Access Compliance Report Public Rights-of-Way (Curb Ramps)

Main Street: COUNTRY_LN Cross Street: SKYLINE_DR Location: N

ADA ID: RPRK211012114926 Ramp Type: Type 7 - Directional 2 Initial Pass/Fail: Fail Overall Compliance: No Severity Score: 2

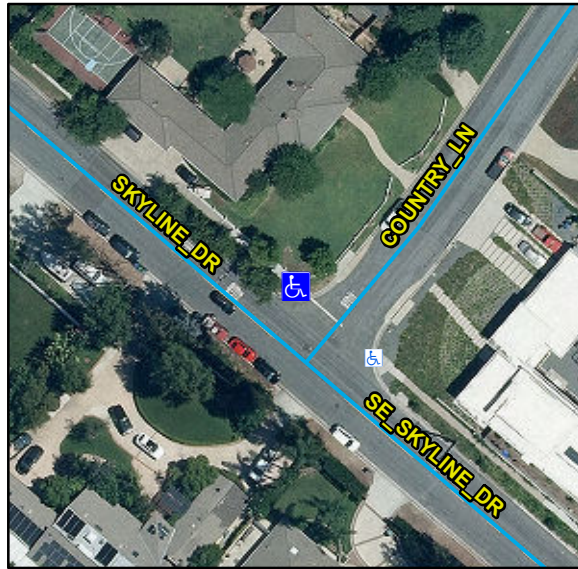
R304.5.3, STD 1115

Compliance	Description	Data	Compliance	Description	Data
N/A	Ramp Length (in)	112	N/A	Flare Type LT	
Yes	Ramp Width (in)	95			N/A
Yes	Ramp Run Slope (%)	7.8	N/A	Flare Slope LT (%)	N/A
No	Ramp Cross Slope (%)	2.6	N/A	Flare Traversable LT	N/A
N/A	Grade Break	N/A	N/A	Flare Type RT	
N/A	Grade Break Slope (%)	N/A			N/A
N/A	Grade Break Cross Slope (%)	N/A	N/A	Flare Slope RT (%)	N/A
	Addl Para Ramp Left?	No	N/A	Flare Traversable RT	N/A
	Addl Para Ramp Right?	No	N/A	DWS Provided	N/A
N/A	Landing Present	N/A	N/A	DWS Contrast	N/A
N/A	Landing Length (in)	N/A	N/A	DWS Length (in)	N/A
N/A	Landing Width (in)	N/A	N/A	DWS Full Width	N/A
N/A	Landing Run Slope (%)	N/A		DWS Offset Type	N/A
N/A	Landing Cross Slope (%)	N/A	N/A	DWS Left Offset (in)	N/A
N/A	Landing Movement Obstructed?	N/A	N/A	DWS Right Offset (in)	N/A
	Landing Movement Type	N/A			
N/A	Landing Shared	N/A			
N/A	Marked Crosswalk 1	No	N/A	Clear Space	N/A
	Crossing 1 Direction	SE	N/A	Clear Space To Crosswalk (in)	N/A

Remove & Replace Entire Ramp.
